*Muskingum Co. SWW # 27, Permit #  
Union Twp.*

**RE: Public Notification for SWIW application for Muskingum County, Union Twp.,  
new well, 1960 Well Services, LLC., Goff SWD #1, injection well**

Response to Comments  
GOFF Saltwater Disposal (SWD)  
#1 Saltwater Injection Well  
1960 Well Services, LLC  
Muskingum County, Ohio

**Subsurface Construction  
For Injection Well**

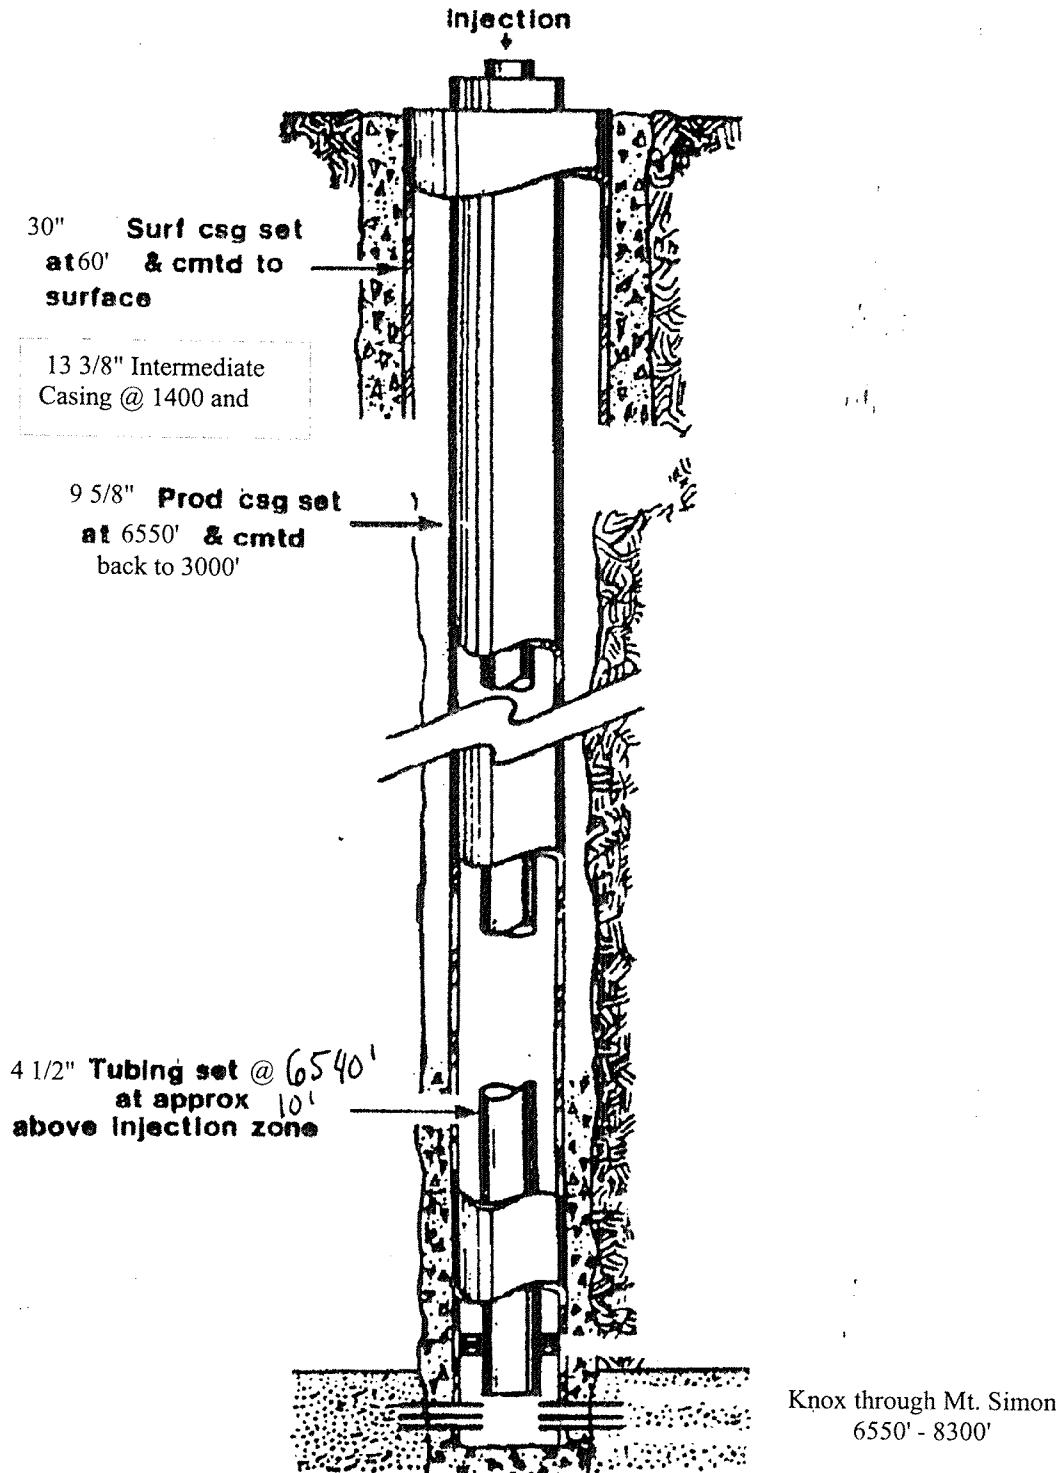
*Comment 4: The depths for the proposed injection zone in the Mt. Simon include everything from the Knox through Mt. Simon. Change the injection zones to Knox through Mt. Simon.*

Response 4: The application has been revised to include the Knox formation and is included in Attachment B.
